Access Compliance Report

Public Rights-of-Way

Intersection ID: 10023065	Main Street: CHALKSTONE_RD	Cross Street: N/A	Location: SW
ADA ID: B7E6B1AEBDBC	Ramp Type: PerpDiag	Initial Pass/Fail: Fail	Overall Compliance: No
		Severity Score: 10

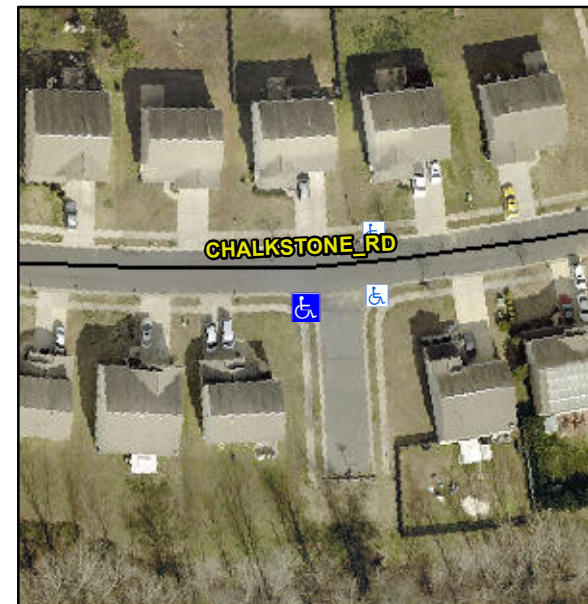
Not Found, R304.5.1, R304.5.3

Compliance	Description	Data	Compliance	Description	Data
N/A	Ramp Length (in)	50.0	Yes	Ramp Slope (%)	6.0
No	Ramp Width (in)	46.0	No	Ramp XSlope (%)	3.5
N/A	Flare Type LT	N/A	N/A	Flare Type RT	N/A
N/A	Flare Slope LT (%)	N/A	N/A	Flare Slope RT (%)	N/A
N/A	Flare Traversable LT?	N/A	N/A	Flare Traversable RT?	N/A
N/A	Landing Length (in)	N/A	N/A	DWS Provided?	N/A
N/A	Landing Width (in)	N/A	N/A	DWS Contrast?	N/A
N/A	Landing Slope (%)	N/A	N/A	DWS Length (in)	N/A
N/A	Landing X Slope (%)	N/A	N/A	DWS Full Width?	N/A
N/A	Landing Curb? (Y/N)	N/A	N/A	DWS Offset (in)	N/A
N/A	Shared Landing?	N/A			
N/A	Gutter Ponding?	N/A	N/A	Gutter Slope (%)	N/A
N/A	Gutter Lip Ht (in)	N/A	N/A	Gutter X Slope (%)	N/A
N/A	Painted X Walk1?	No	N/A	Painted X Walk2?	No
	X Walk 1 Direction	To E		X Walk 2 Direction	To N
N/A	X Walk 1 Width (in)	N/A	N/A	X Walk 2 Width (in)	N/A
	X Walk 1 Slope (%)	0.5		X Walk 2 Slope (%)	3.9
	X Walk 1 X Slope (%)	4.2		X Walk 2 X Slope (%)	1.5

Remove & Replace Curb Ramp With Two New Directional Ramps or Equivalent.
